BRIAR GROVE SUBDIVISION

APPLICATION NUMBER 2 DATE January 17, 2008

REQUEST Subdivision

DETAIL SITE PLAN

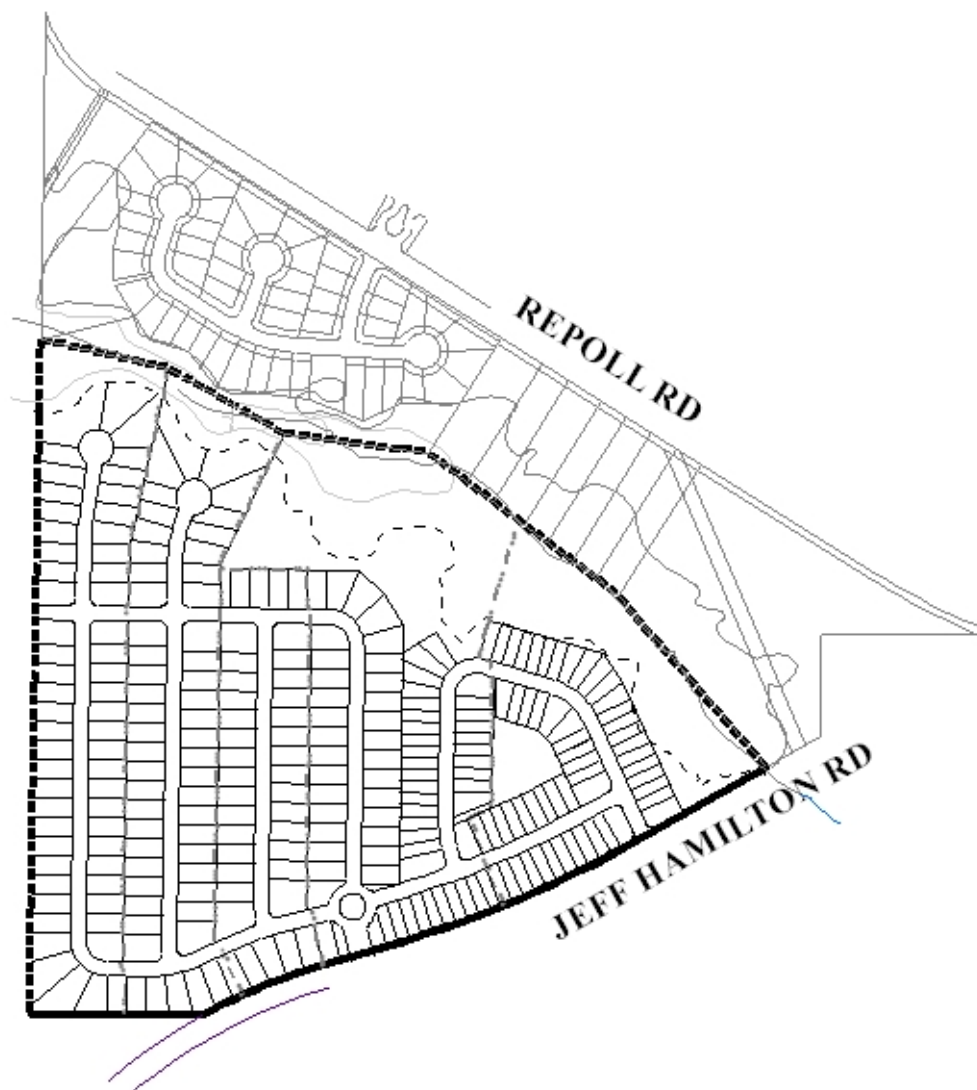
The site fronts Jeff Hamilton Road, a planned major street having an existing right-of-way of 80-feet. The Major Street Plan, a component of the Comprehensive Plan requires a minimum 100-foot right-of-way; therefore, the dedication of sufficient right-of-way to provide 50-feet from the centerline of Jeff Hamilton Road would be required.

The applicant proposes to create 271 lots, of which approximately 93 lots will “typically” be approximately 5,200 square feet in size, which is less than the 7,200 square feet required by Section V.D.3. of the Subdivision Regulations. The applicant proposes to provide development for these 93 lots as a “patio garden home” section of the overall development. The applicant states that the development would allow 50-percent building site coverage for all lots and reduced side yard setbacks for the smaller (40' x 130') lots. It should be noted that the development illustrates a 1.2 acre park as one of the amenities of the development.

The plat also shows extensive wetlands along Jeff Hamilton Creek which is considered to be wetlands, is present on the site. The potential presence of wetlands indicate that the area may be environmentally sensitive; therefore, the approval of all applicable federal, state and local agencies would be required prior to the issuance of any permits or land disturbance activities.

The application proposes new streets, which must be constructed and dedicated to Mobile County Engineering standards prior to signing the Final Plat. Access management is a concern, due to the location of Lots 1-10, 70-75, 157, 158, 239, and 260-271, should be denied direct access to Jeff Hamilton Road, and since lots 11, 21, 39, 40, 57, 76, 89, 94, 108, 109, 124, 125, 139, 140, 156, 182, 183, 200, 201, 217, 250, and 271 are corner lots therefore, a note should be placed on the Final Plat limiting each lot to one curb cut each, with the size, design and location to be approved by County Engineering.

Detention/retention and common areas are depicted on the preliminary plat; therefore, a note should be placed on the Final Plat stating maintenance of these areas will be the responsibility of the property owners.

- 1) the approval by the Planning Commission of a Traffic Impact Study for Briar Grove Subdivision;*
- 2) dedication of sufficient right-of-way to provide 50-feet from the centerline of Jeff Hamilton Road;*

- 3) *the approval of all applicable federal, state and local agencies for wetlands prior to the issuance of any permits or land disturbance activities;*

- 4) *certification via placement of a note on the plat stating that the property owner/developer will comply with all local, state and federal regulations regarding endangered, threatened or otherwise protected flora and fauna;*

- 5) *the placement of a note on the final plat stating that the development will be designed to comply with the storm water detention and drainage facility requirements of the City of Mobile storm water and flood control ordinances, and requiring submission of a letter from a licensed engineer certifying that the design complies with the storm water detention and drainage facility requirements of the City of Mobile storm water and flood control ordinances prior to the signing of the final plat. Certification is to be submitted to the Planning Section of Urban Development and County Engineering;*

- 6) *the placement of a note on the Final Plat stating that Lots 1-10, 70-75, 157, 158, 239, and 260-271 denied direct access to Jeff Hamilton Road and allowed one curb cut to the new street, with the size, design and location to be approved by Mobile County Engineering Department;*

- 7) *the placement of a note on the Final Plat stating that Lots 11, 21, 39, 40, 57, 76, 89, 94, 108, 109, 124, 125, 139, 140, 156, 182, 183, 200, 201, 217, 250, and 271 are corner lots therefore, a note should be placed on the Final Plat limiting each lot to one curb cut each, with the size, design and location to be approved by County Engineering.*

- 8) *revision of the plat to label the lot with its size in square feet, or placement of a table on the plat with the same information;*
- 9) *the placement of a note on the final plat stating that any lots which are developed commercially and adjoin residentially developed property must provide a buffer, in compliance with Section V.A.7 of the Subdivision Regulations; and*

- 10) *placement of a note on the plat stating that maintenance of the detention and common areas is the responsibility of the subdivision's property owners.*
